**ALERT SERVICE BULLETIN
REVISION NOTICE**

SUBJECT: REVISION "C" TO ALERT SERVICE BULLETIN 430-04-31:

**TAIL ROTOR BLADE P/N 222-016-001-123, -123M, -131 AND -139M, INSPECTION
AND REWORK OF**

NO. 430-04-31

Figure 1. Blade Inspection Area

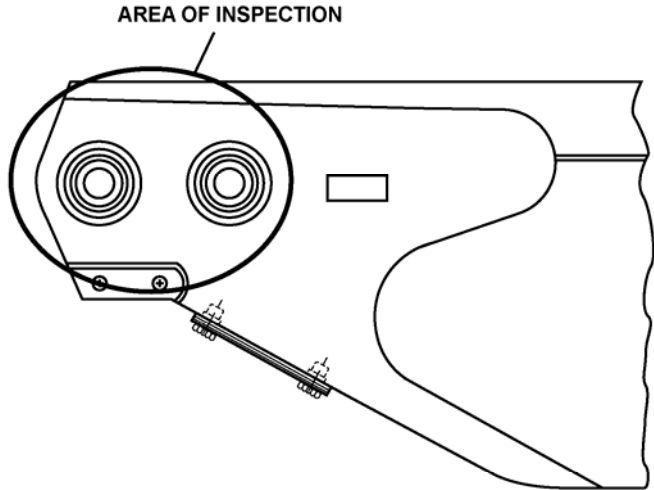
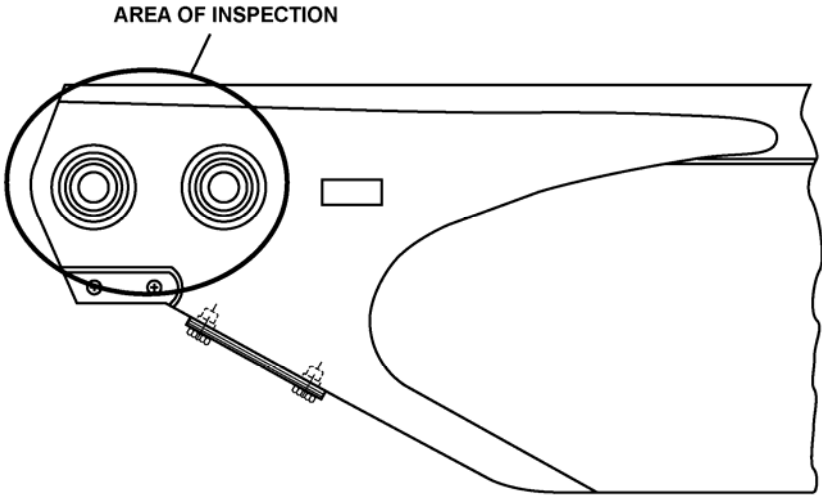
- a. Wipe down both surfaces of each blade around the blade feathering bearings using aliphatic naphtha (C-305) or detergent (C-318) or equivalents. Refer to Figure 1.
 - b. Closely examine the cleaned surface, on both sides of the blade, paying particular attention to the area around both bearings. If no crack is found in the paint, the inspection is complete until next inspection.
 - c. If a crack is found in the paint, maintenance personnel must proceed with step 2.
2. Remove the suspected blade from the helicopter. Refer to BHT-430-MM-7, Chapter 64.

- a. Wipe down both surfaces of each blade around the blade feathering bearings using aliphatic naphtha (C-305) or detergent (C-318) or equivalents. Refer to Figure 1.
 - b. Using a 10X power magnifying glass, closely examine the cleaned surface, on both sides of the blade, paying particular attention to the area around both bearings.
 - c. If no crack is found in the paint the inspection is complete until next inspection.
 - d. If a crack is found in the paint, proceed with step 2.
2. Remove the tail rotor blade from the helicopter. Refer to BHT-430-MM-7, Chapter 64.
